Re: Joint Draft Environmental Impact Report/Environmental Impact Statement (EIR/EIS) for
East County Substation Project (State Clearinghouse No. 2009121079; DOI-BLM-CA-D070-
2010-0027-EIS (ECO SUB))

San Diego Gas & Electric Company (SDG&E) submits the attached comments to the California Public Utilities Commission (CPUC) and United States Department of Interior, Bureau of Land Management (BLM) on the Joint Draft Environmental Impact Report/Draft Environmental Impact Statement (EIR/EIS) for the proposed East County Substation Project (ECO Substation Project or Project).

Figure A-1: February 2011 ECO Substation Design

Figure A-3: Preliminary Underground Alignment Drawing 5 of 10

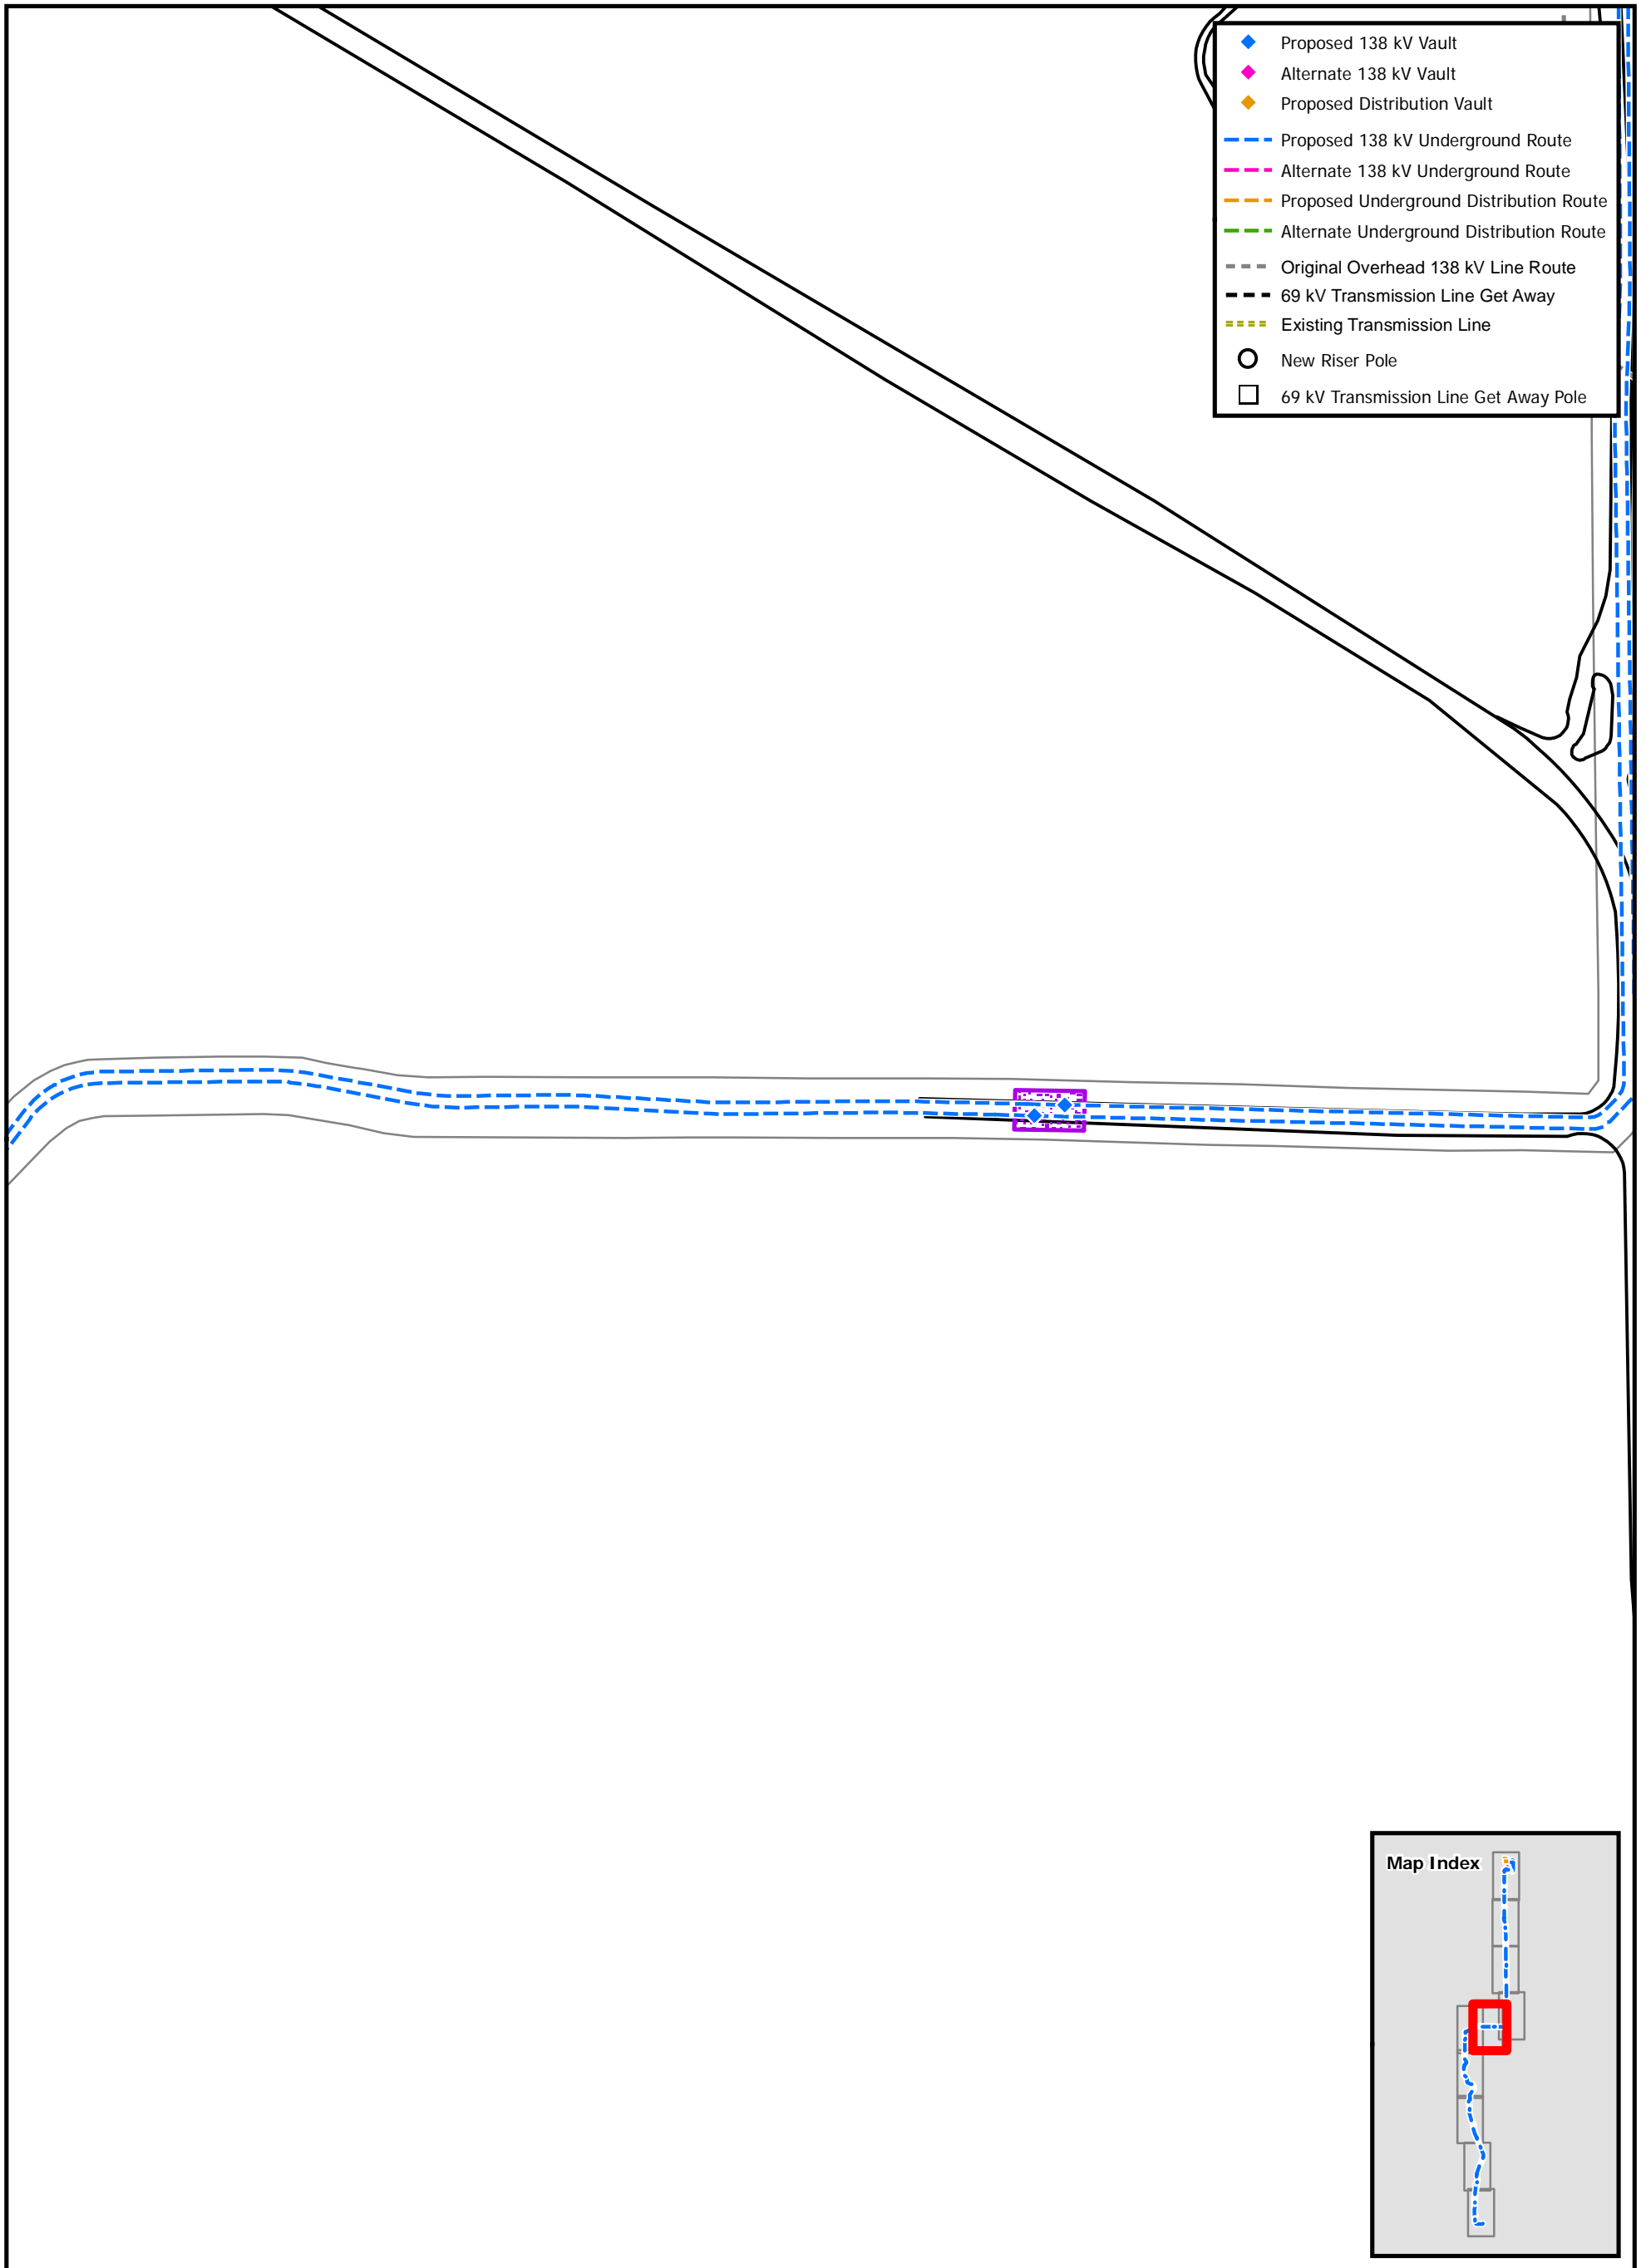
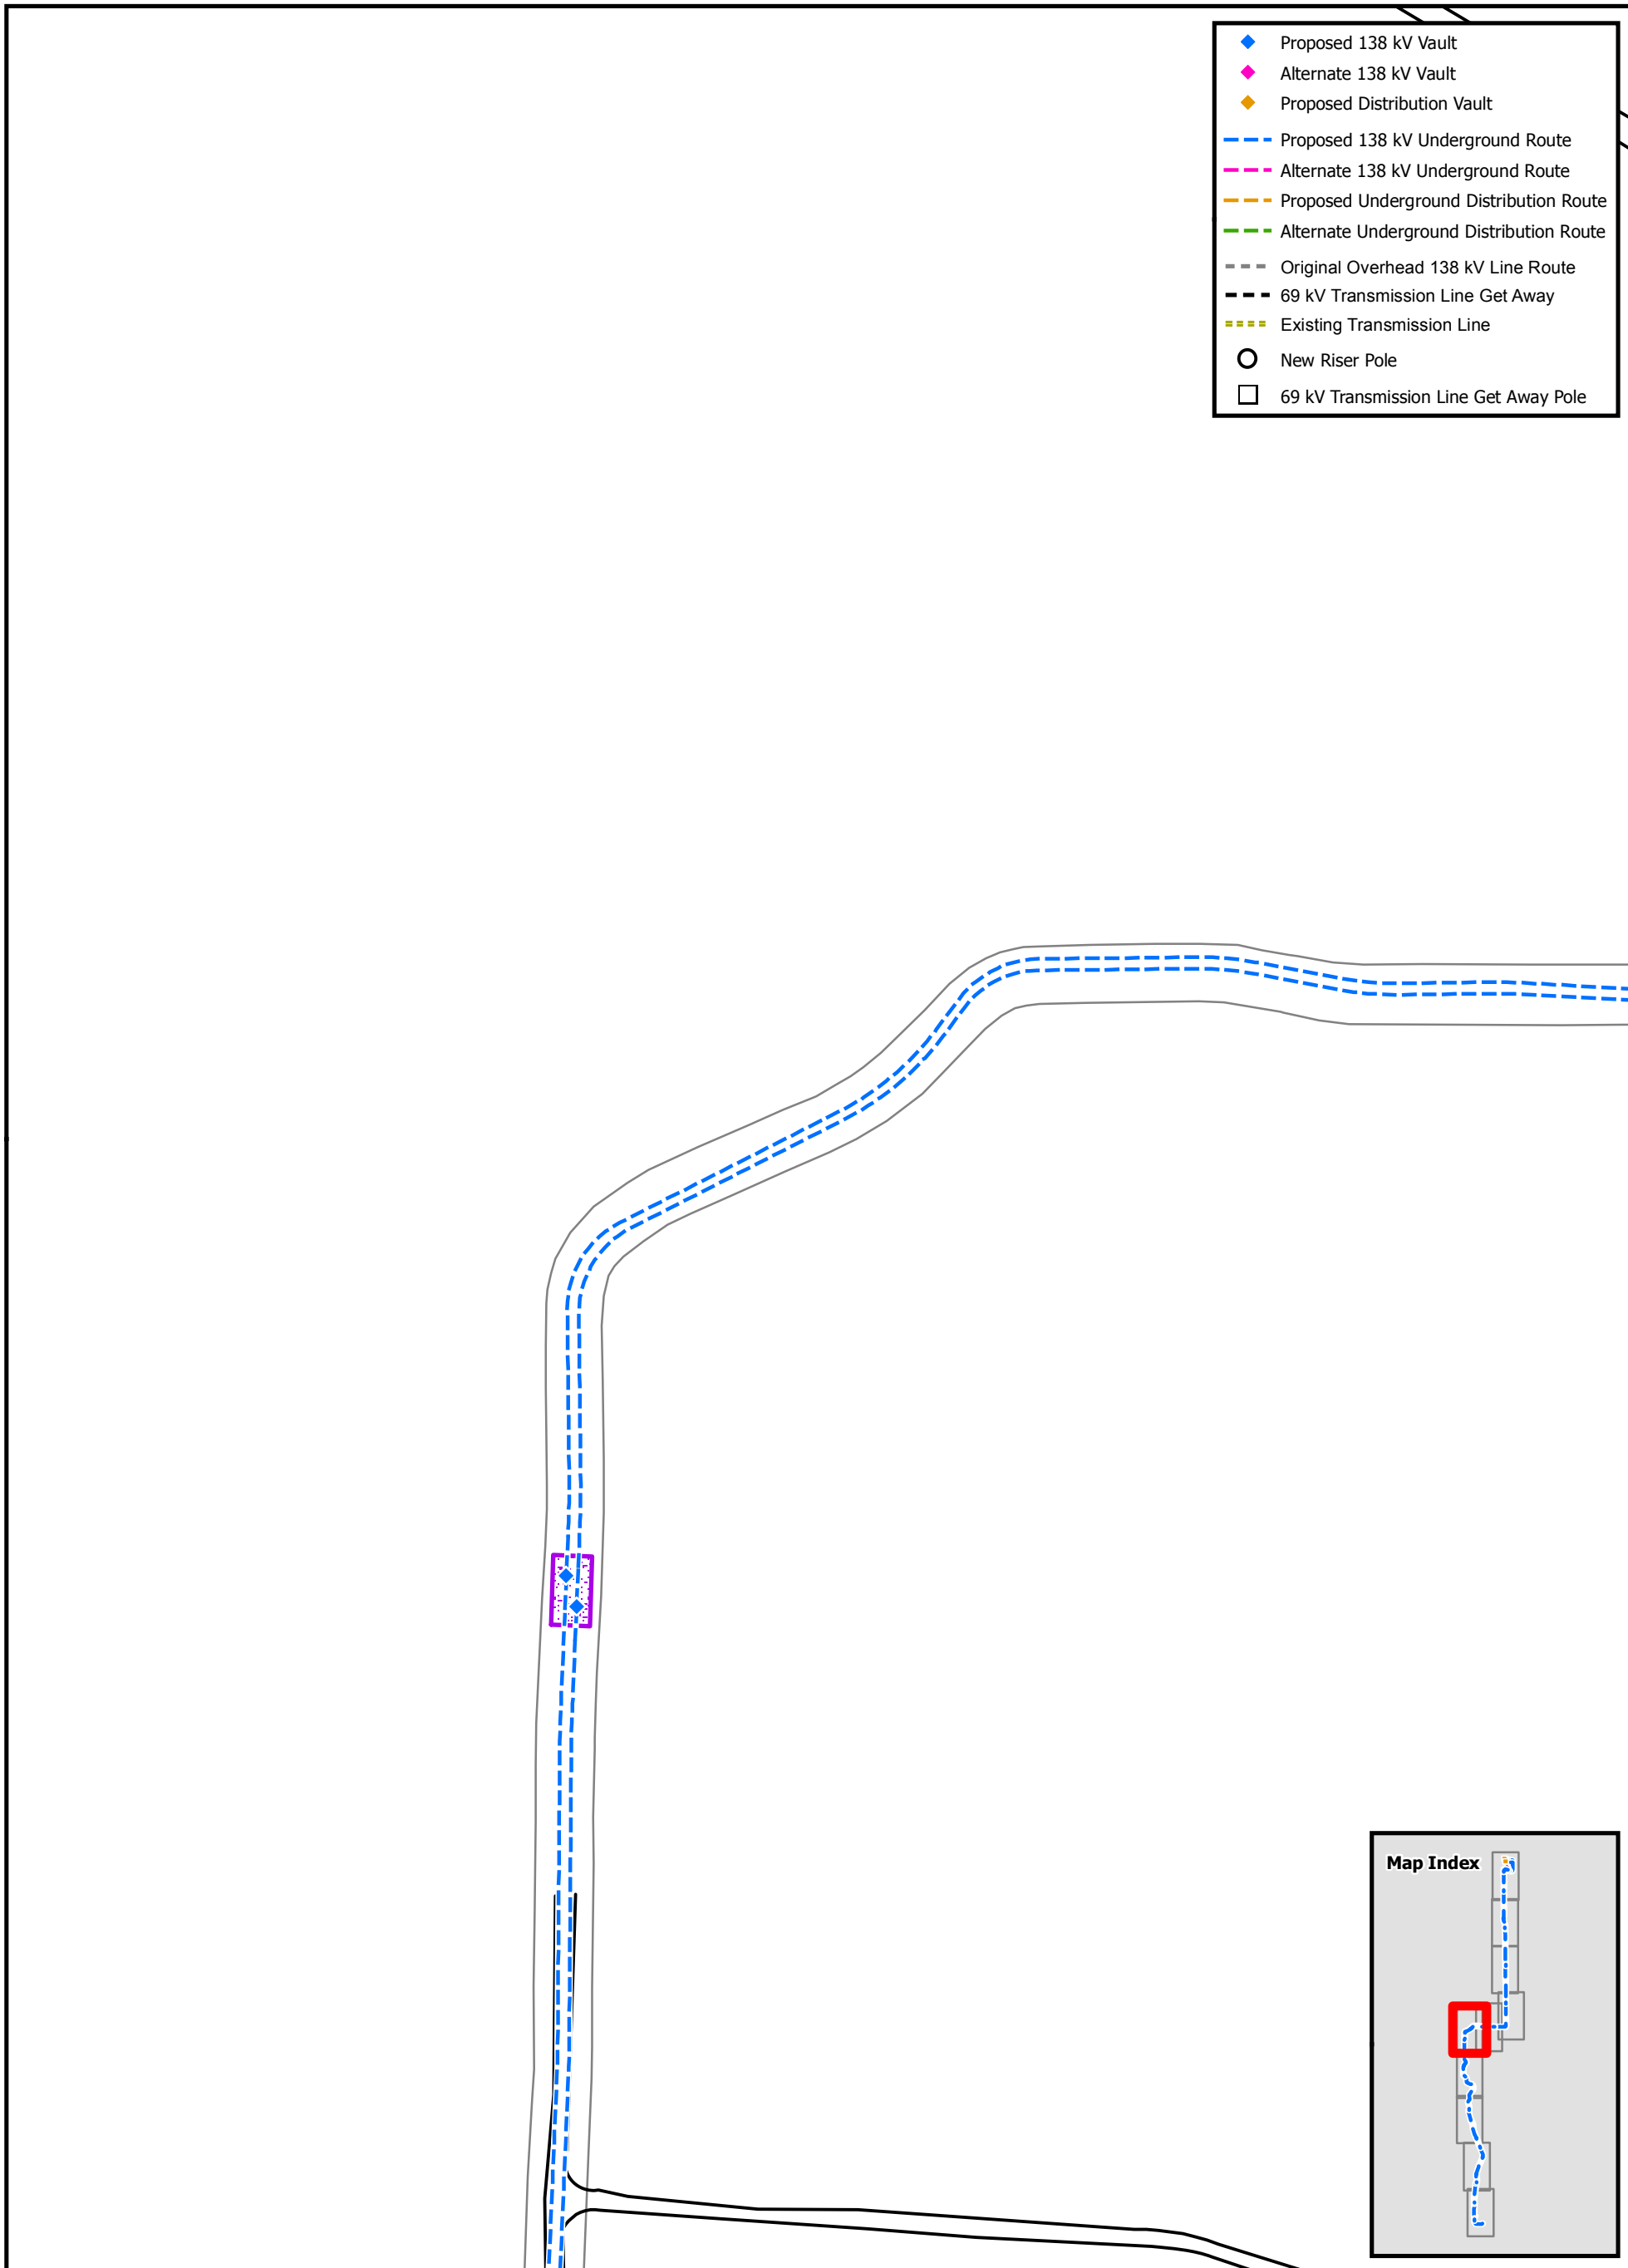
The impacts of the underground alignment were then determined based on a worst-case scenario (since there are two alternative routes into the substation as depicted in Figure A-3: Preliminary Underground Alignment Drawing that are substantially similar). As demonstrated in Table A-7: Preliminary Partial Underground Impacts, these impacts would not be substantial and would not therefore be significant.
